## TECHNICAL SERVICE BULLETIN

### Shift Knob Rotates Without Brake Pedal Depressed, Transmission Remains In Park (P)

**22-2343**  
19 September 2022

Figure 1

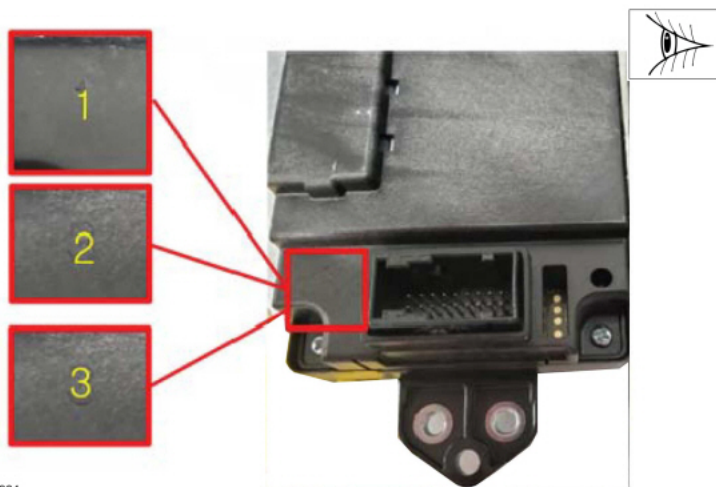
2. Inspect the GSM at the location identified in Figure 1.

(1). If the GSM is marked with numbers 1, 2, or 3, proceed to Step 4.

(2). If the GSM is marked with number 4 or blank, re-install GSM and proceed to Step 3.

3. Reprogram the GSM using the latest software level of the Ford Diagnostic and Repair System (FDRS). Repair is complete.

4. Replace the GSM. Follow the WSM Section 307-05.
